- 1.1 This document sets out the design office response to a Road Safety Audit (RSA) Stage 1 undertaken by Mott MacDonald in relation to a Toucan crossing on Howes Lane in relation to Axis J9 Phase 3 proposals. The full RSA report is attached as **Appendix A**.

Howes Lane, Bicester

Road Safety Audit
Stage 1

23 March 2022

B. Location Plan – Howes Lane

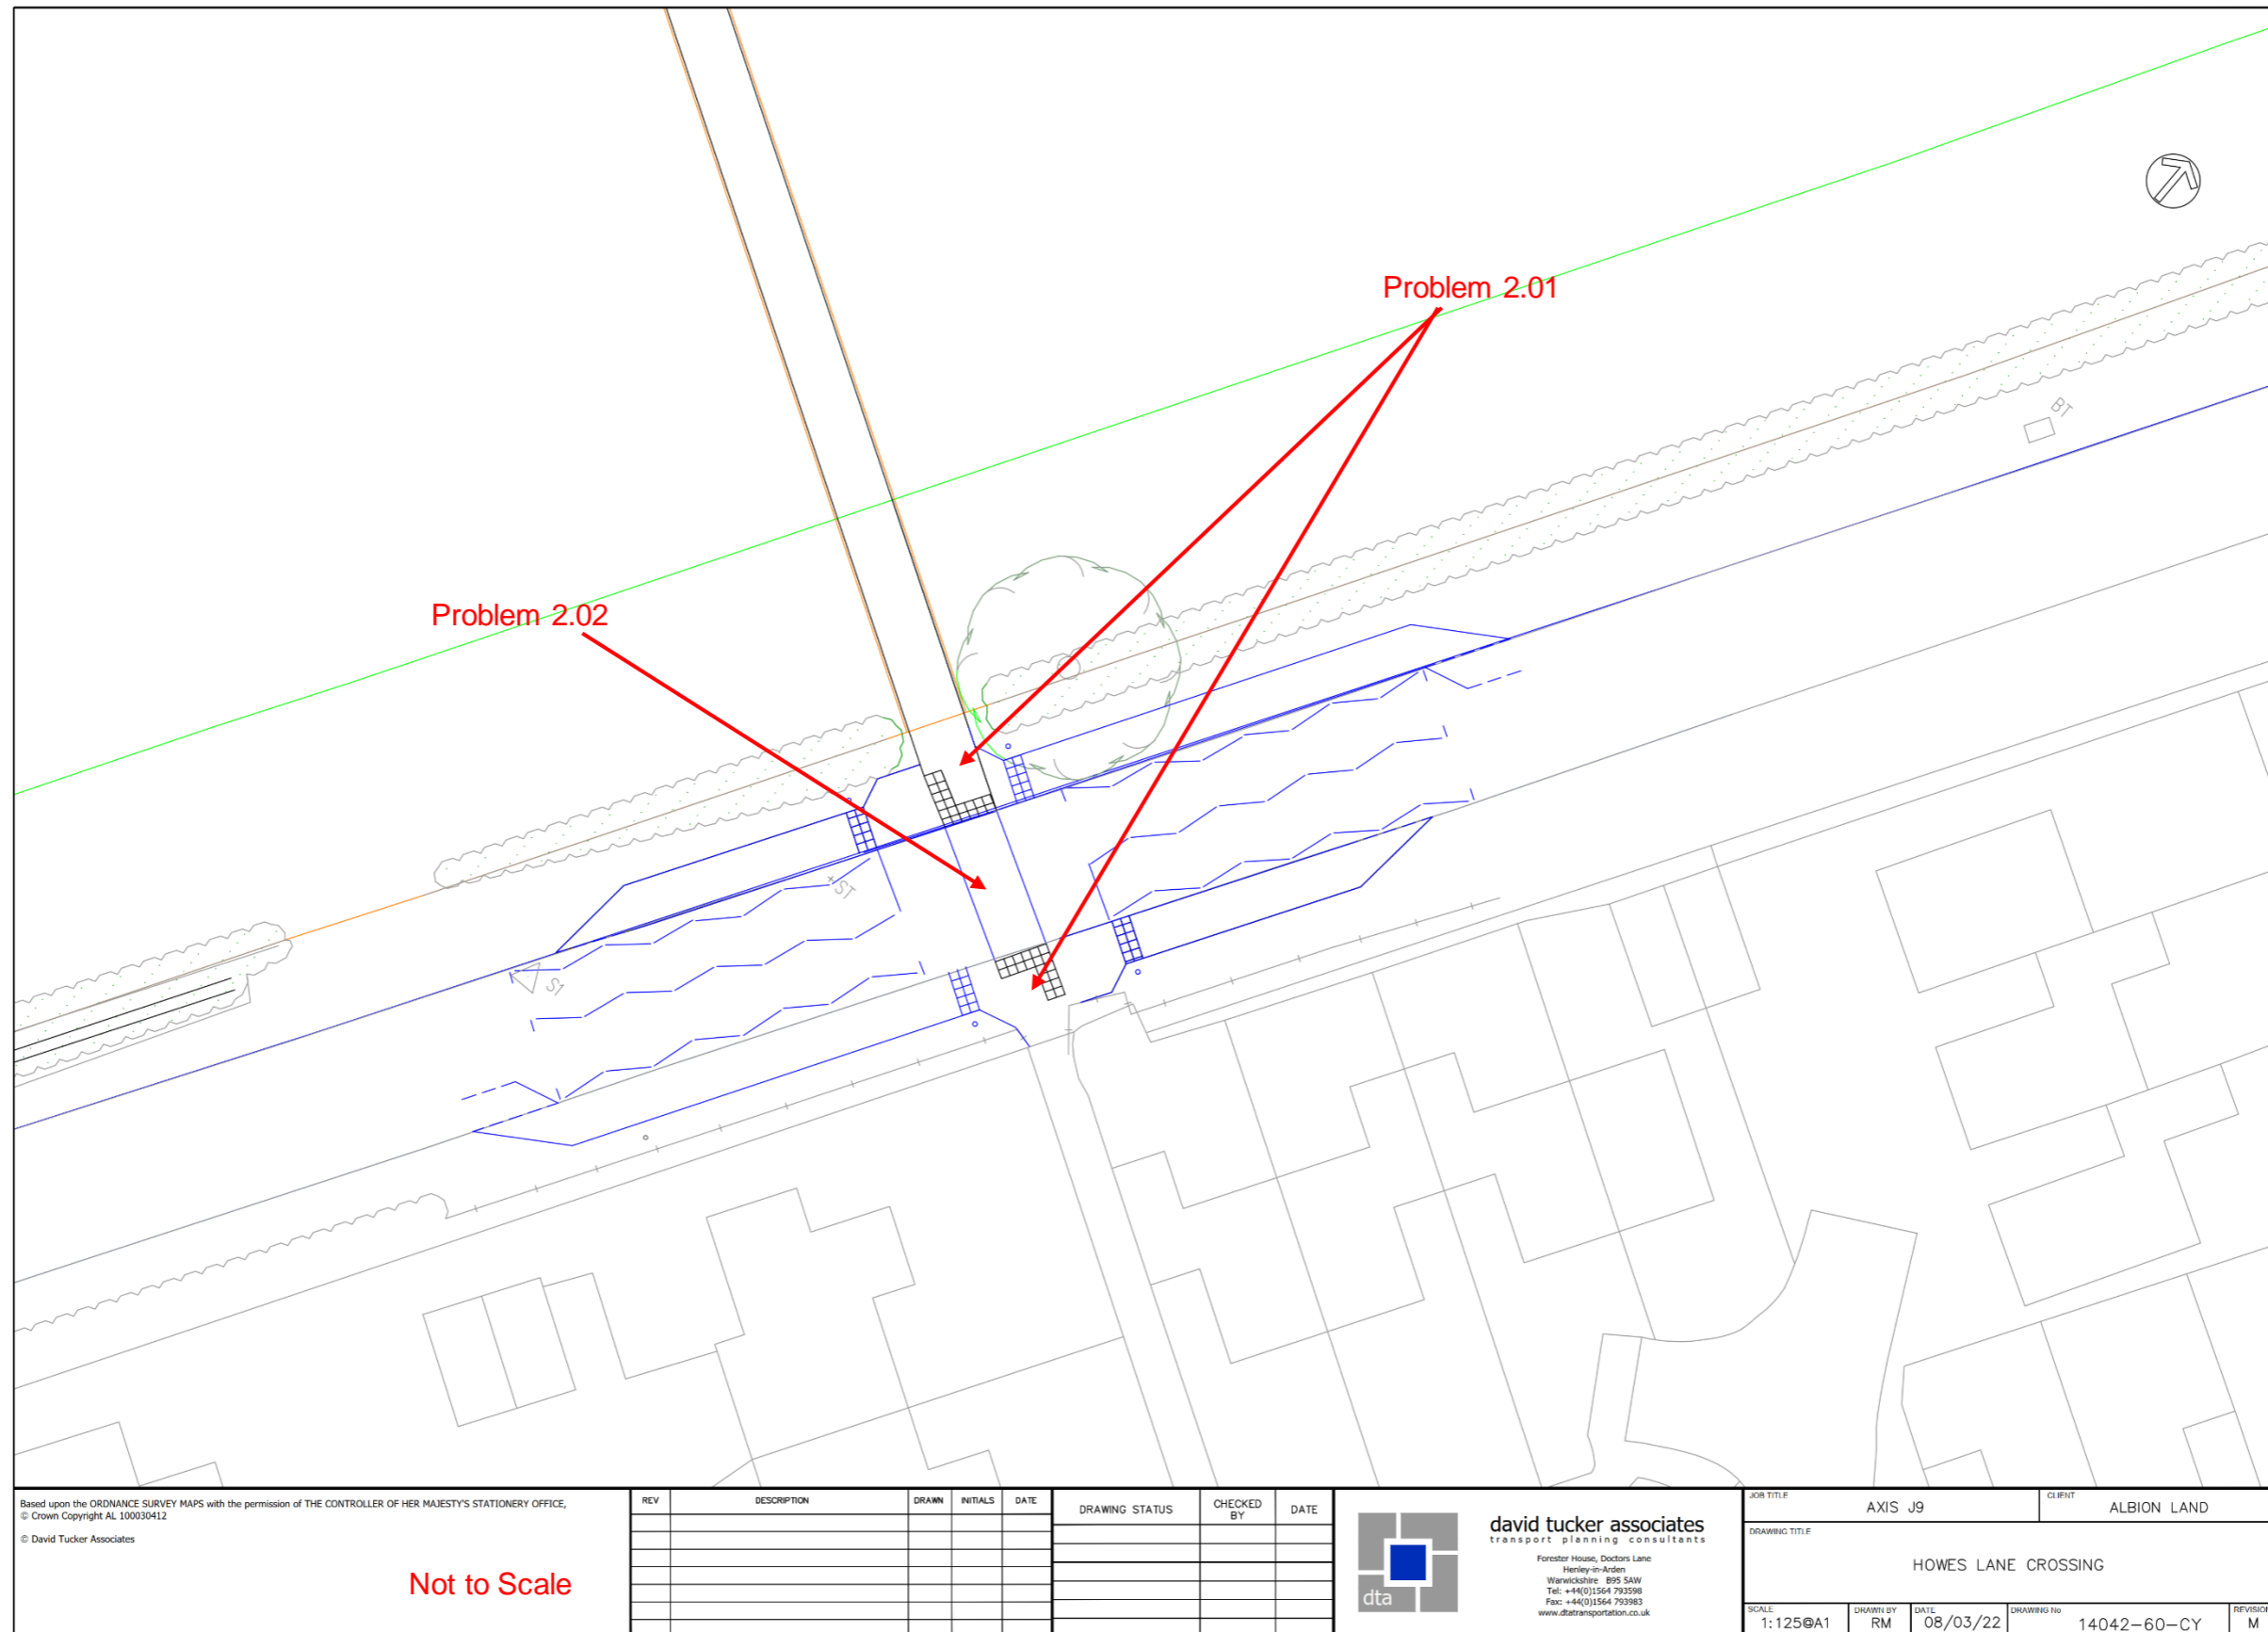
The proposed Toucan Crossing is shown 'in line' with the existing footway link to Wansbeck Drive and the proposed footway / cycleway into the development. As such, pedestrians or cyclists approaching the crossing facility may do so at inappropriate speed increasing the likelihood of NMUs failing to stop before entering the carriageway. This may increase the risk of collisions with approaching vehicles. A guardrail 'chicane' is present at the western end of the existing footway link to Wansbeck Drive to mitigate against this, but a similar arrangement is not proposed on the new footway / cycleway.

It is recommended that either the Toucan Crossing is 'offset' from the footway / cycleway approaches on both sides of the Howes Lane, or a guardrail 'chicane' is installed on the new footway / cycleway on the western side of Howes Lane. The existing 'chicane' on the eastern side should be retained.

It is unclear whether street lighting is to be provided at the Toucan Crossing. A lack of street lighting may result in approaching motorists failing to observe a pedestrian / cyclist waiting to, or starting to, cross the carriageway. This may lead to an increased risk of collisions between crossing pedestrians / cyclists and approaching vehicles. This may be exacerbated by approaching motorists focussing on the traffic signals rather than pedestrians / cyclists who might cross contrary to the red crossing indicator.

It is recommended that appropriate levels of street lighting are provided at the Toucan Crossing.

This recommendation is accepted and the recommendation to introduce a guardrail chicane on the new footway / cycleway on the western side of Howes Lane would be addressed at the detailed design stage.

This recommendation is accepted and would be address through the detailed design as part of the S278 works.
